<b>Product / Process Change Notification (PCN)</b>	
<input checked="" type="checkbox"/> Major change <input type="checkbox"/> Minor change	
<p><b>PCN #:</b> PCN_WPME-FDSM_20220520_5</p> <p><b>Affected Series:</b> FDSM; 173950378, 173950578</p> <p><b>PCN Date:</b> February 21, 2022</p> <p><b>Effective Date:</b> May 20, 2022</p>	<p><b>Change Category:</b></p> <input type="checkbox"/> Equipment / Location <input checked="" type="checkbox"/> General Data <input type="checkbox"/> Material <input type="checkbox"/> Process <input type="checkbox"/> Product Design <input type="checkbox"/> Shipping / Packaging <input type="checkbox"/> Supplier <input type="checkbox"/> Software
<p><b>Contact:</b> Product Management</p> <p><b>Phone:</b> +49 (0) 7942 - 945 5001</p> <p><b>Fax:</b> +49 (0) 7942 - 945 5179</p> <p><b>E-Mail:</b> pcn.eisos@we-online.com</p>	<p><b>Data Sheet Change:</b></p> <input checked="" type="checkbox"/> Yes <input type="checkbox"/> No <p><b>Attachment:</b></p> <input checked="" type="checkbox"/> Yes <input type="checkbox"/> No

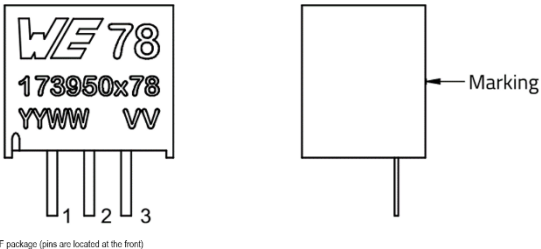
<p><b>Description and purpose of change:</b></p> <p>For the purpose of a datasheet information enlargement, Würth Elektronik has updated the internal content of the datasheet.</p> <p>This is a datasheet correction only. There will be no change in form, fit, function, quality or reliability of the product.</p>	
<p><b>Detail of Change:</b></p> <p>1. Updated front page drawing. (page 1)</p>	
<p style="text-align: center;">Before</p> 	<p style="text-align: center;">After</p>

Before	After
<p><b>PACKAGE</b></p> 	<p><b>PINOUT (PACKAGE TYPE F)</b></p>

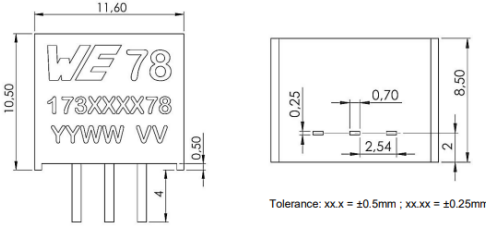
2. Updated pinout drawing to include pin 1 marking. (page 2)

Before	After
<p><b>PHYSICAL DIMENSIONS</b></p>  <p>Tolerance: xx.x = ±0.5mm ; xx.xx = ±0.25mm</p>	<p><b>PHYSICAL DIMENSIONS</b></p>

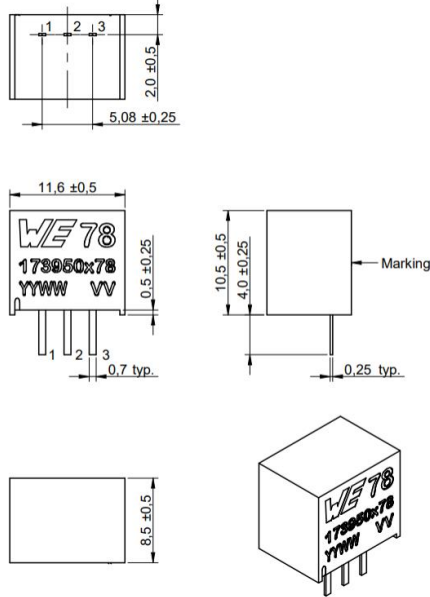
3. Updated physical dimensions drawings to include pin 1 marking. (page 37)
